ADDENDUM NUMBER THREE

10 November 2025

NC Department of Natural and Cultural Resources
Fort Fisher Aquarium – Renovation & Expansion
Phase 1
SCO ID #17-18042-02A

LS3.35

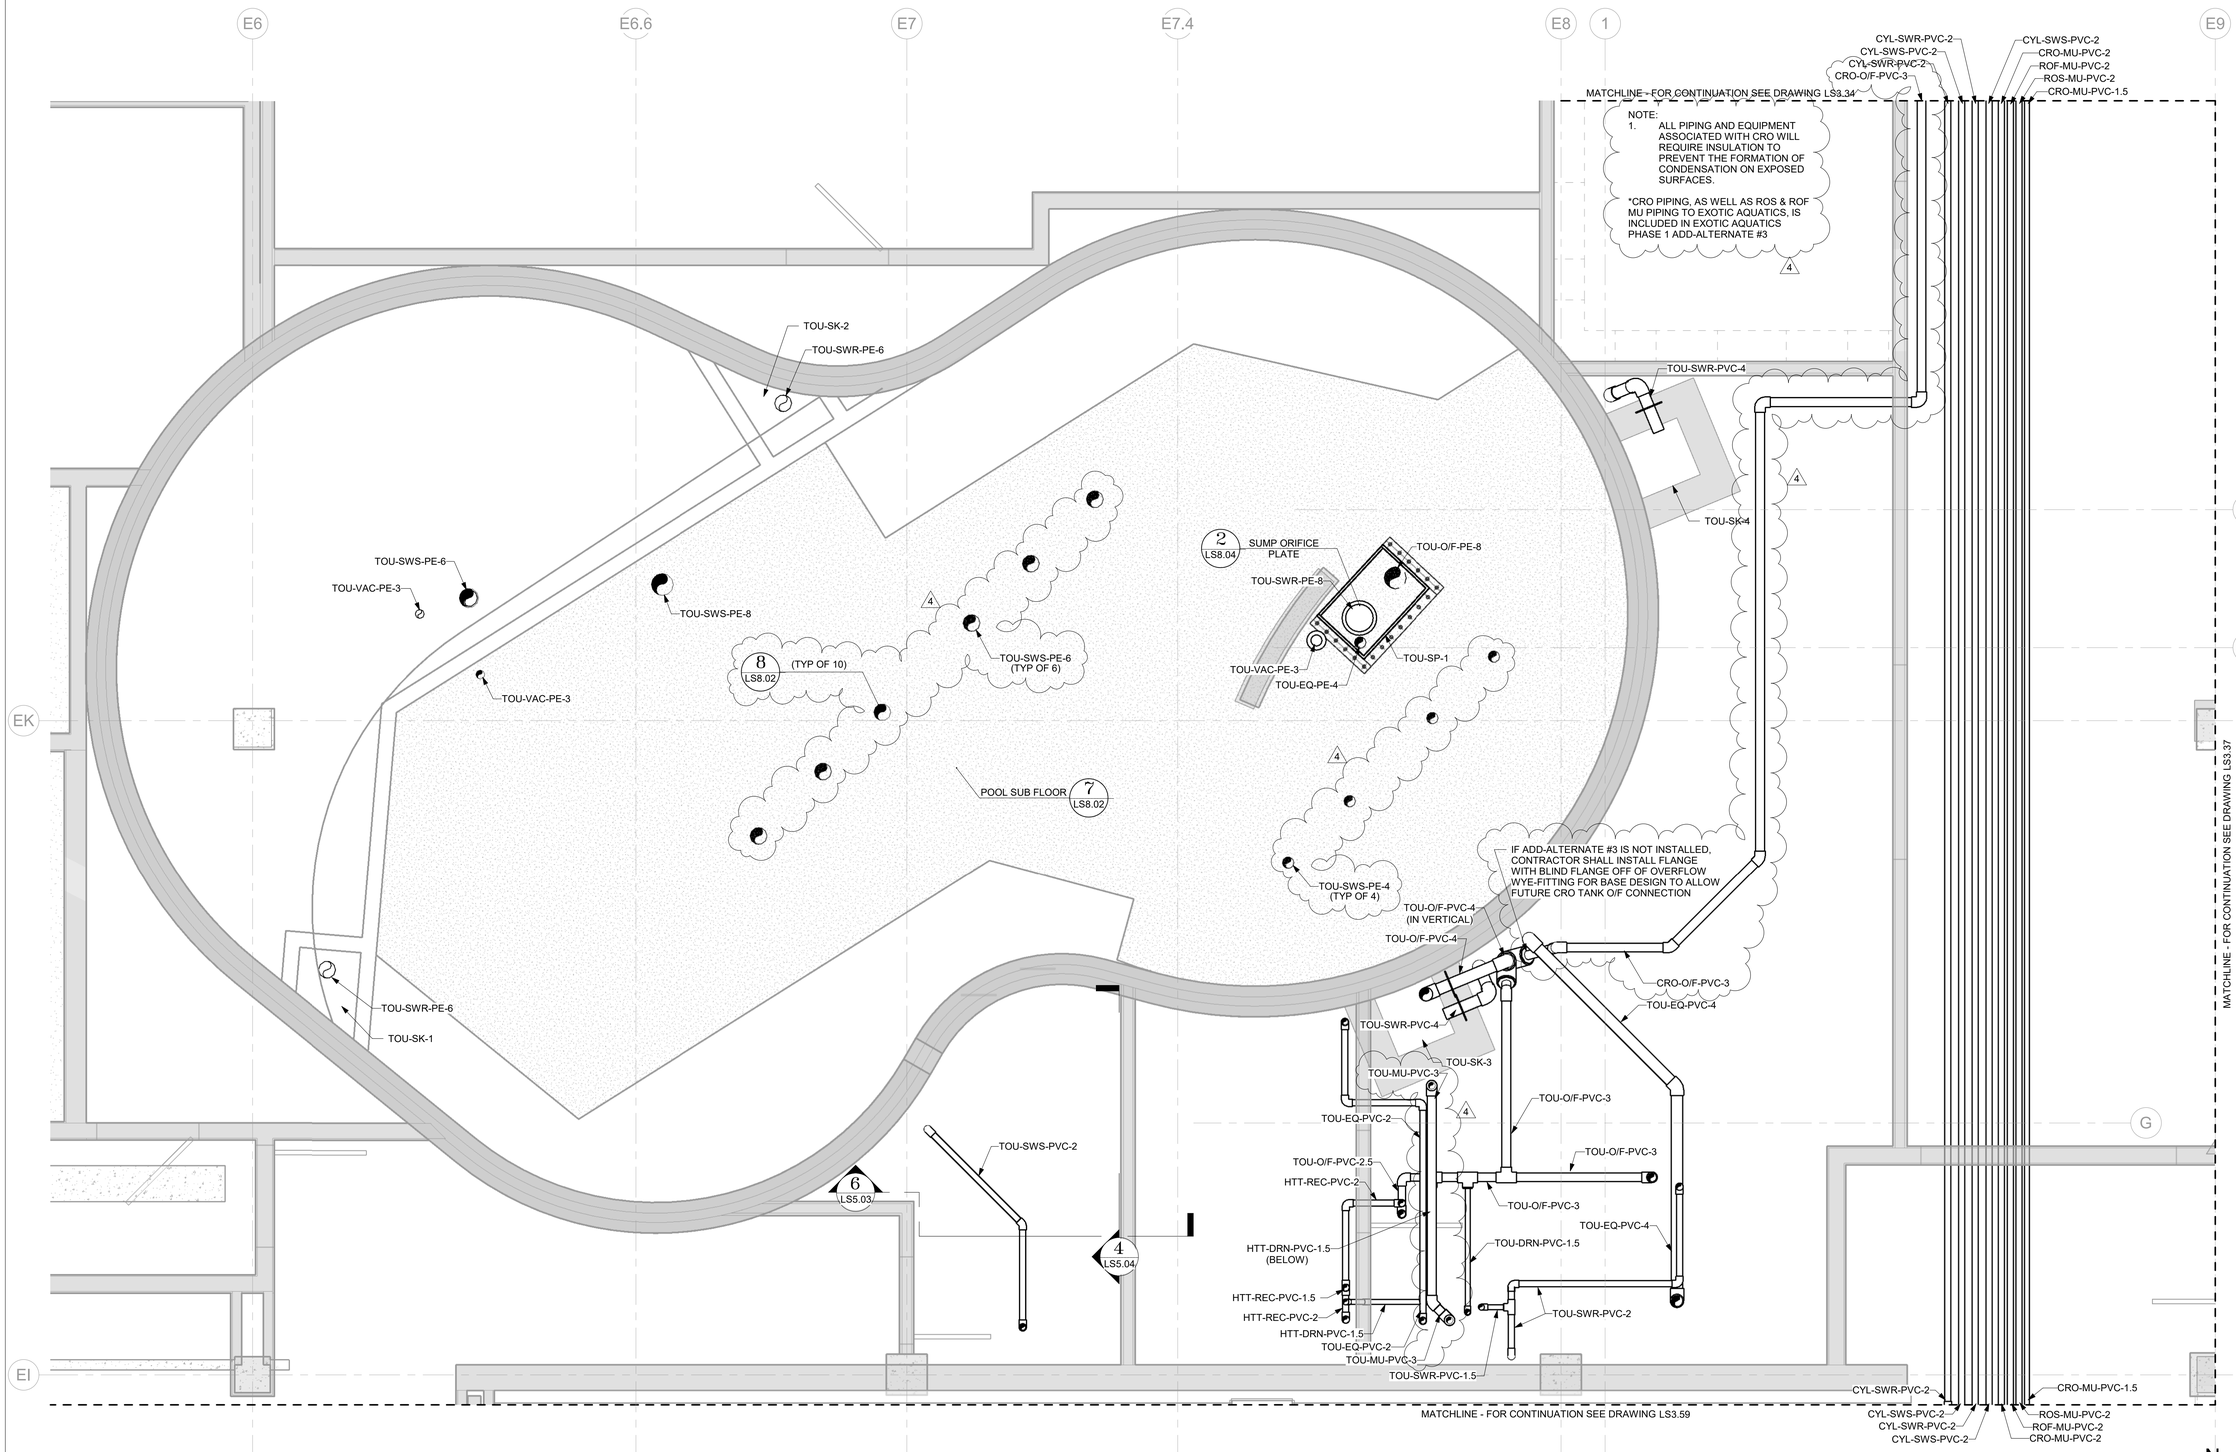
123. LS3.35: ENLARGED LSS PLAN - 1ST FLOOR - EL. 9.67' TO 12.17'
   a. Removed unnecessary detail call out.
124. LS3.36: ENLARGED LSS PLAN - 1ST FLOOR - EL. 13.83' TO 16.5'

LS3.37

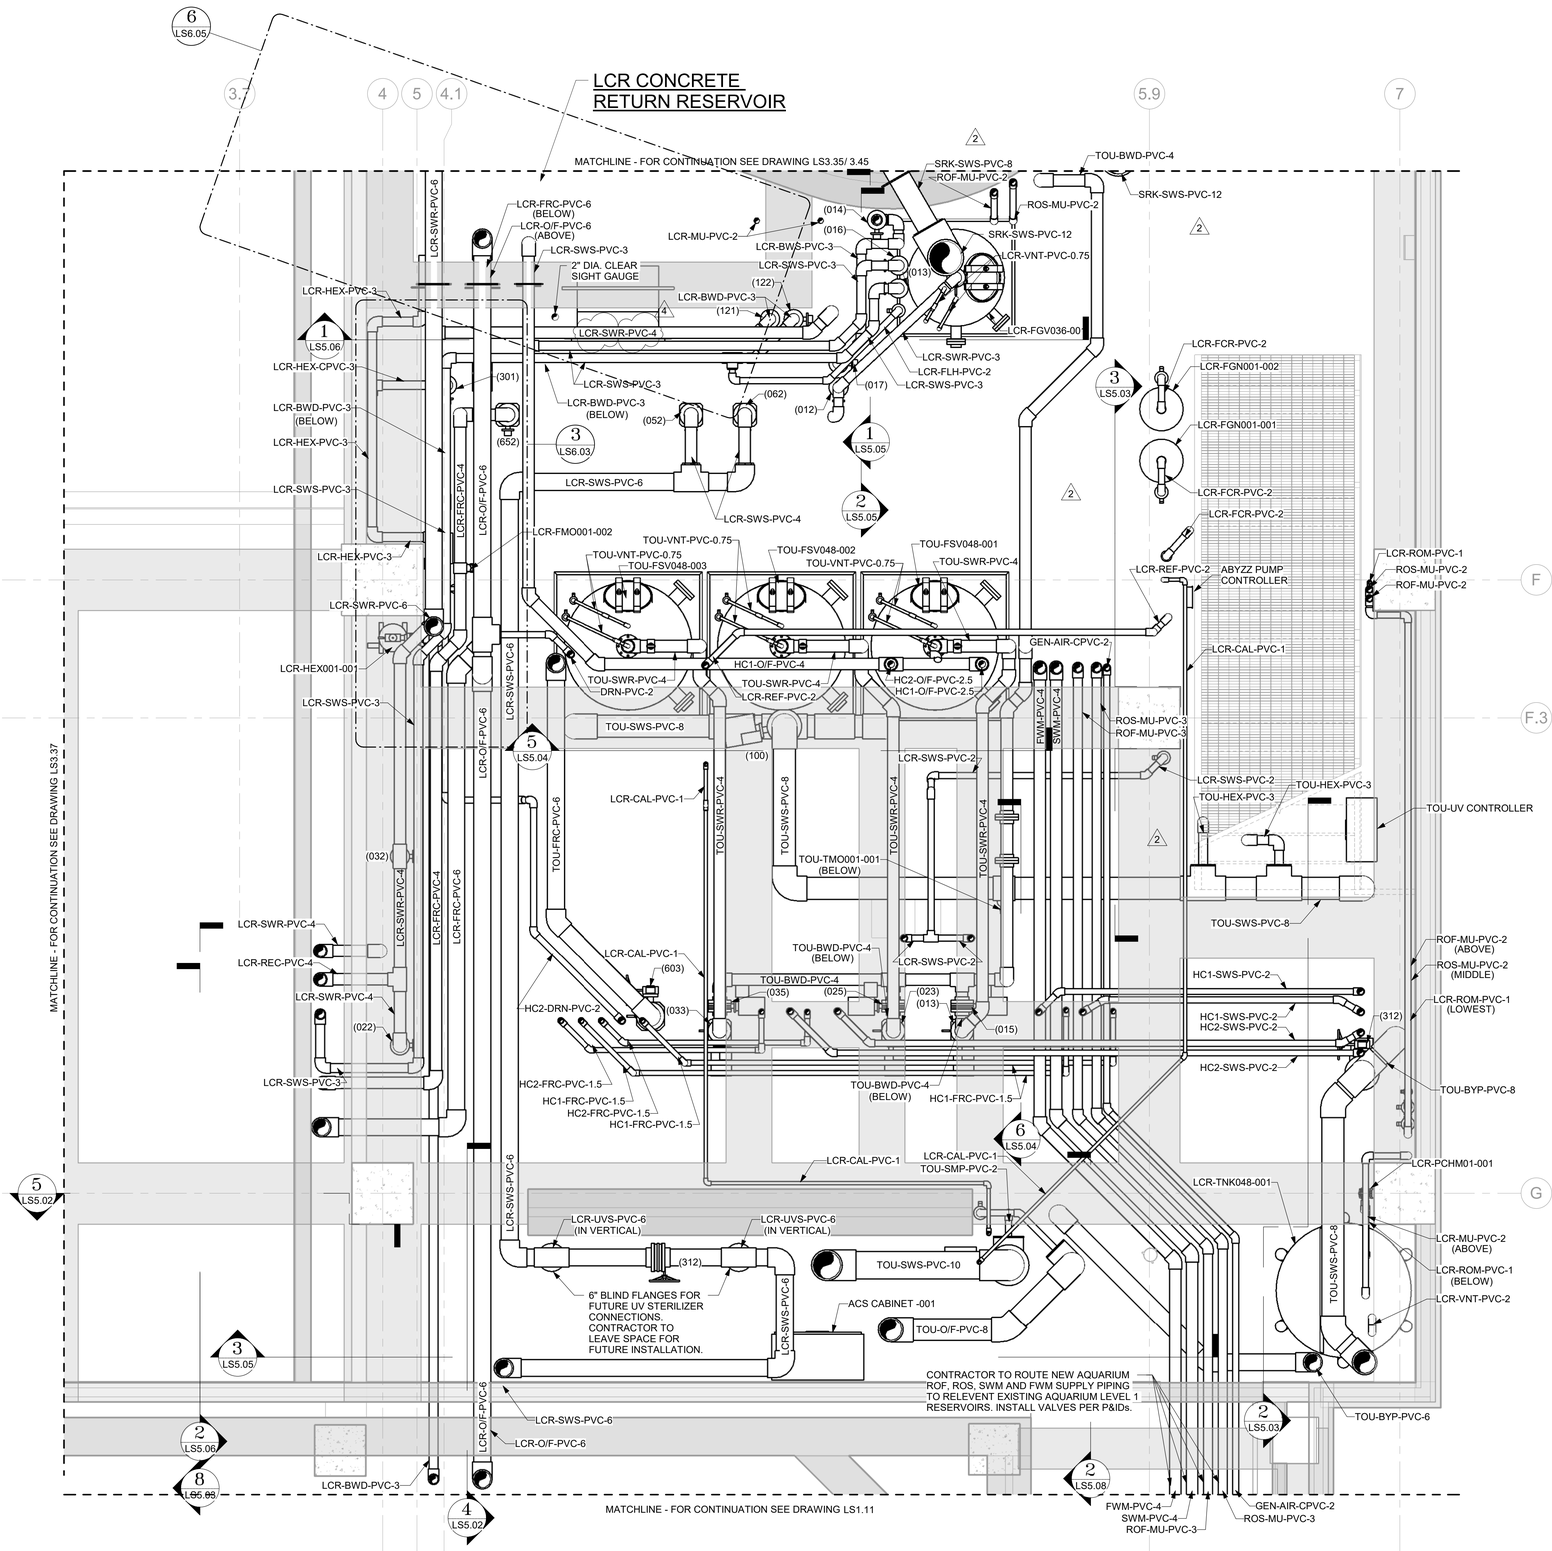
125. LS3.37: ENLARGED LSS PLAN - 1ST FLOOR - EL. 9.08' TO 17.83’
   a. Reroute AQC overflow pipe to outfall to prevent conflict with enlarged beam.
126. LS3.38: ENLARGED LSS PLAN - 1ST FLOOR - EL. 11.33' TO 17.83'

LS3.38

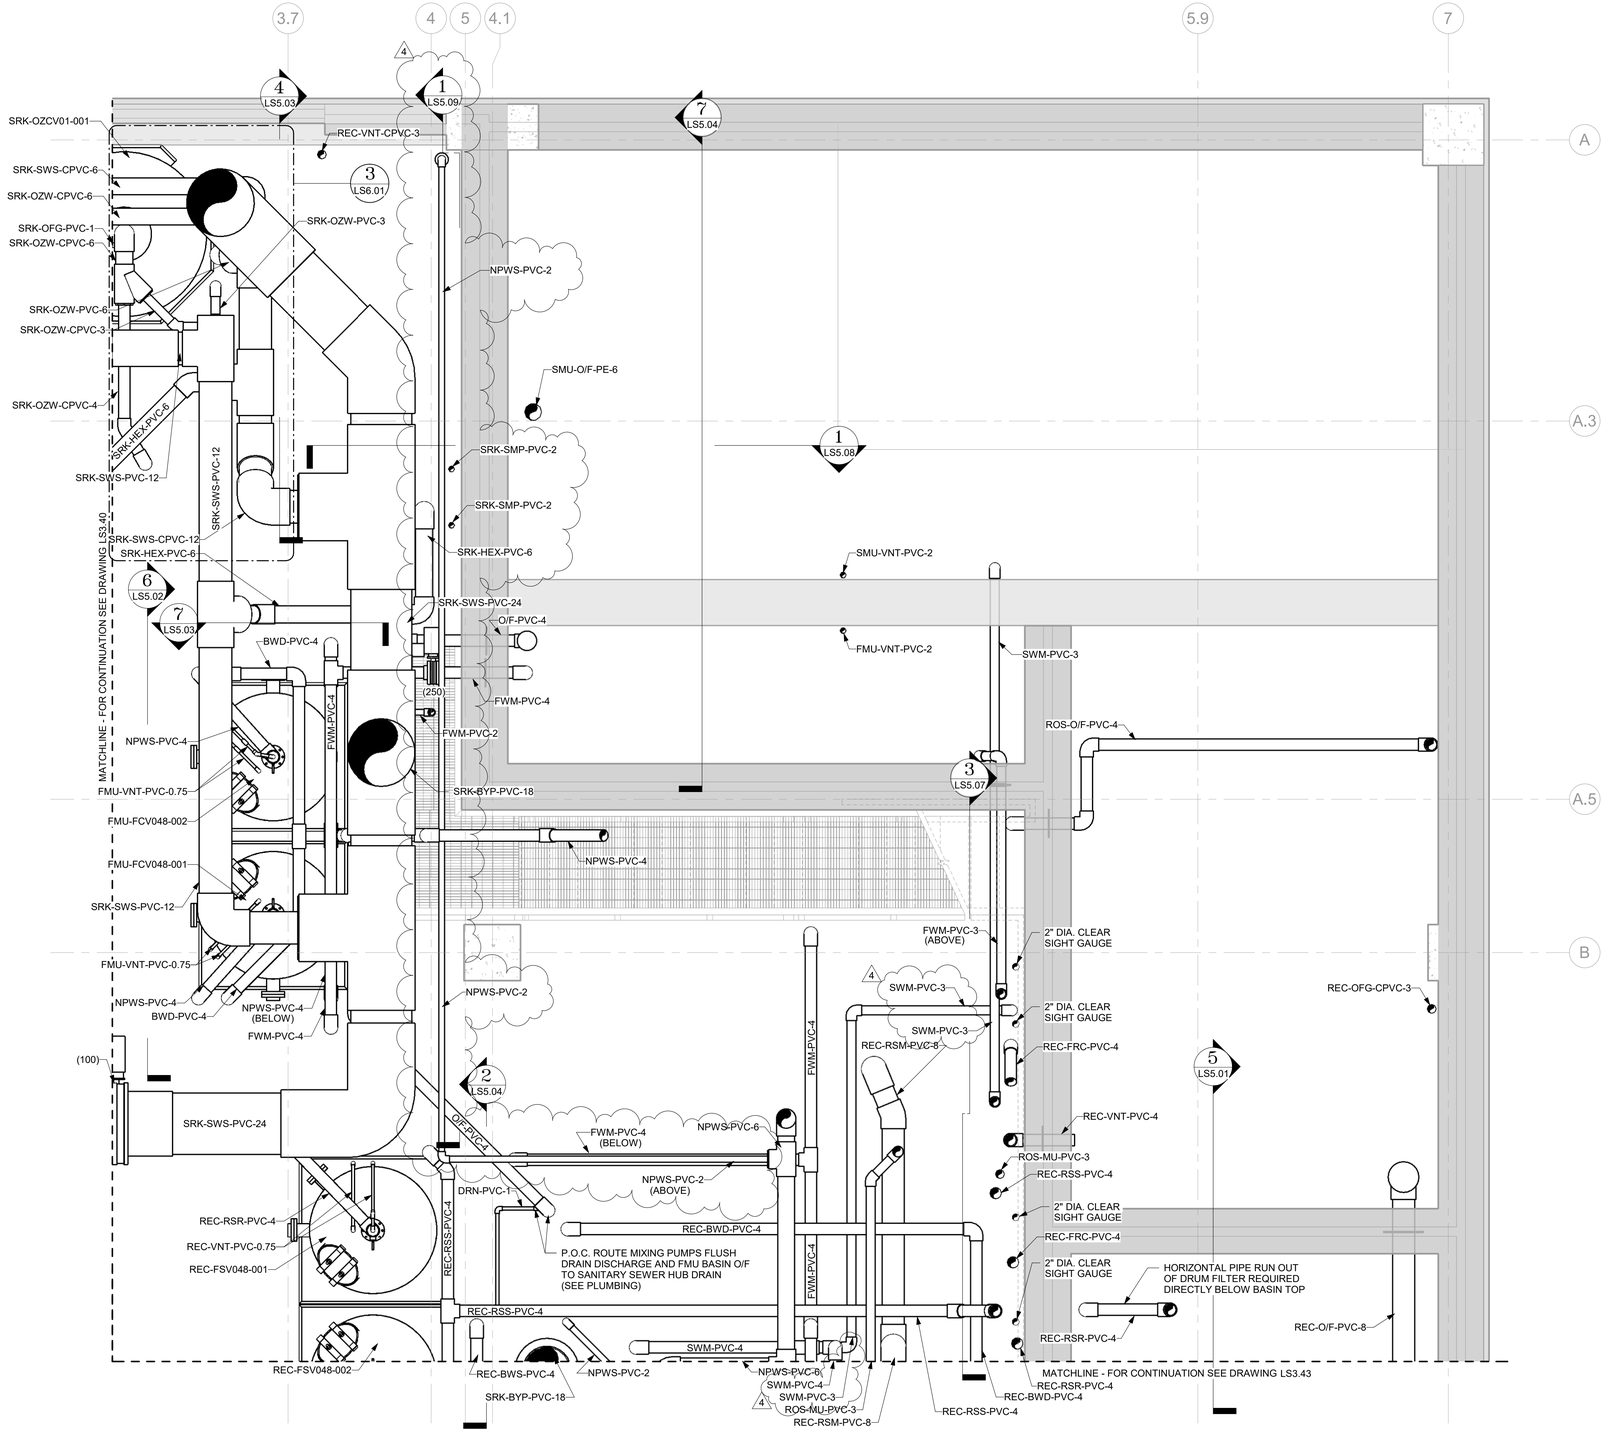
a. Pipe tag fix
127. LS3.41: ENLARGED LSS PLAN - 2ND FLOOR ADMIN - EL. 18.36' TO 23.94'
   a. Add section 1/5.09 to clarify piping.
   b. Add pipe tag for clarification.

LS3.47

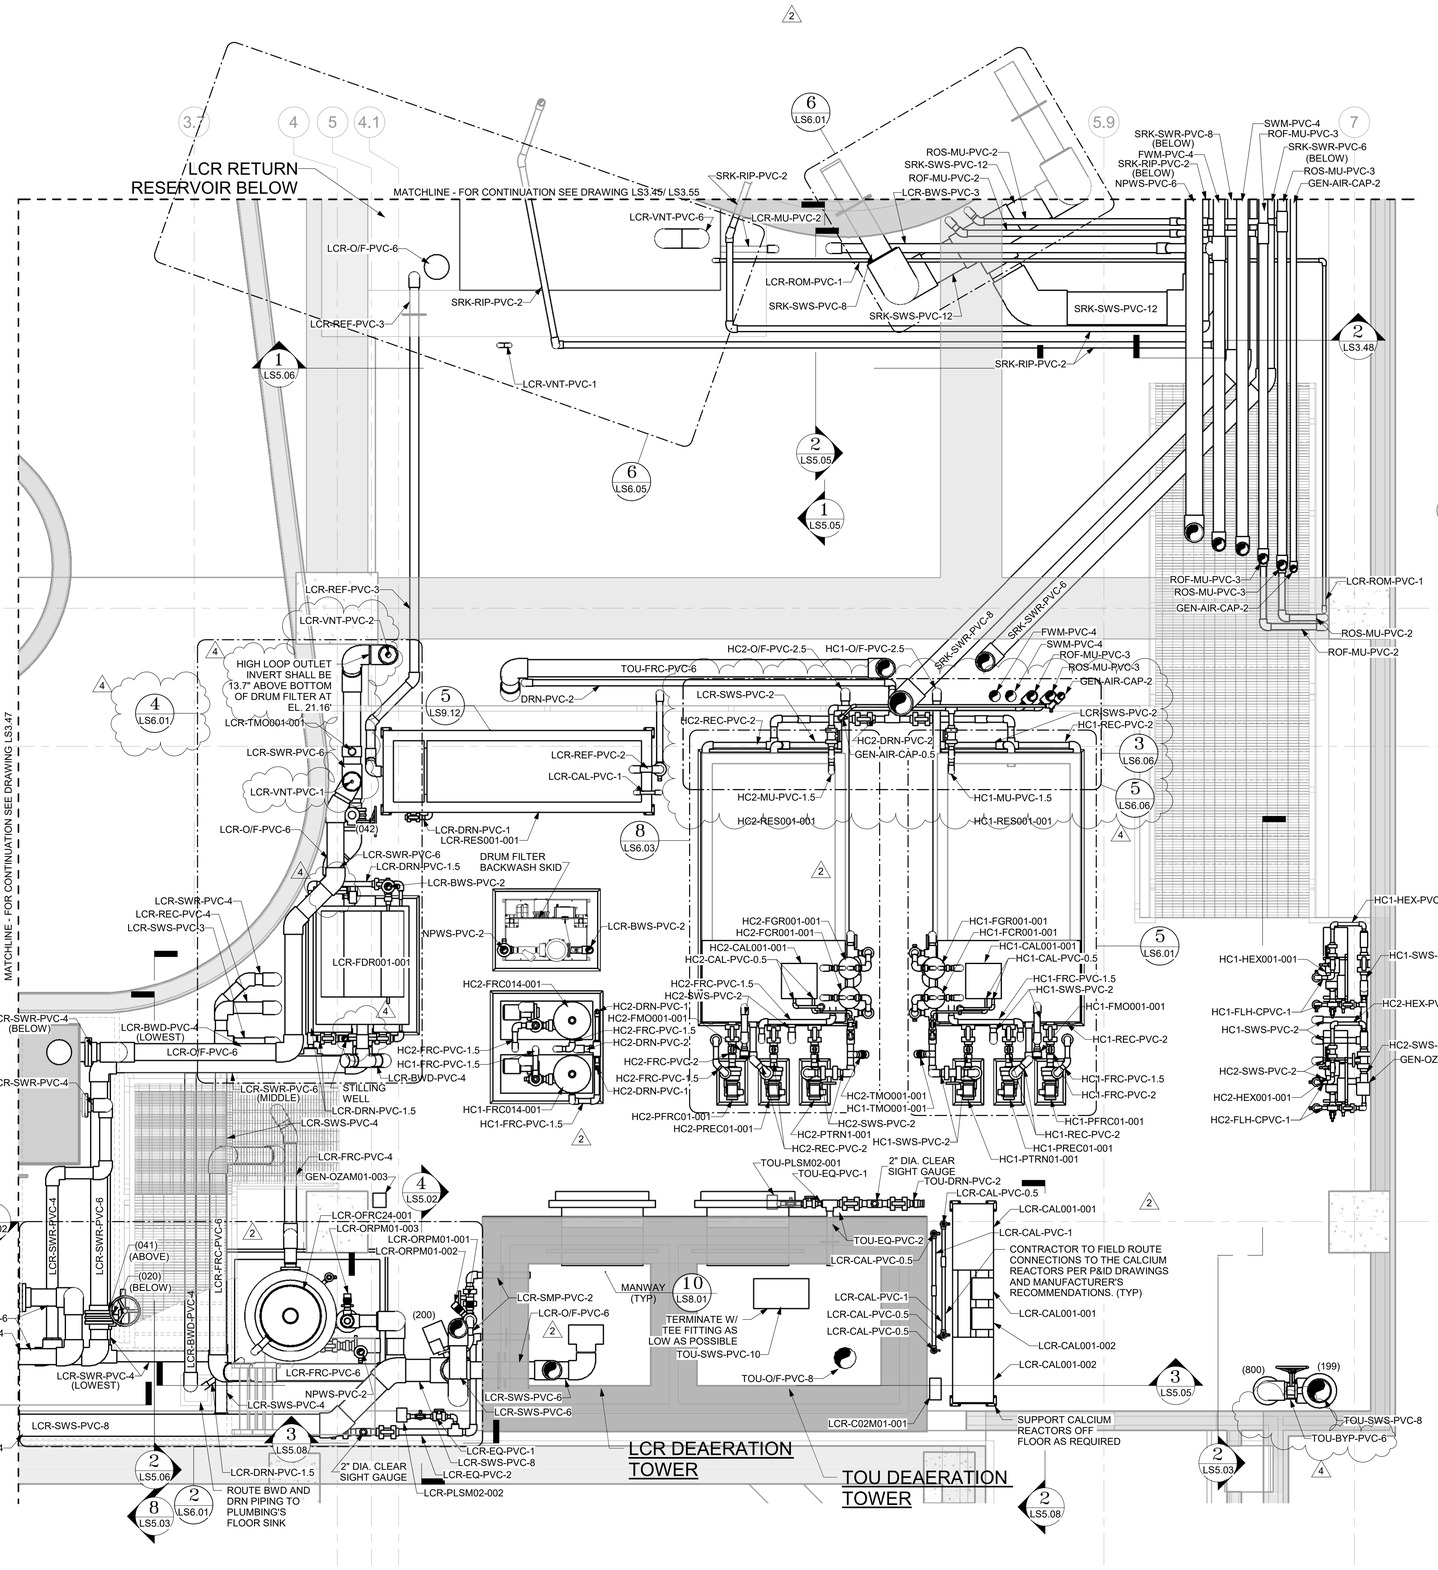
131. LS3.47: ENLARGED LSS PLAN - 2ND FLOOR ADMIN - EL. 18.36' TO 26.69'
   a. Add tag for clarification.

b. Add iso call out for new 4/ls6.06 iso for clarification
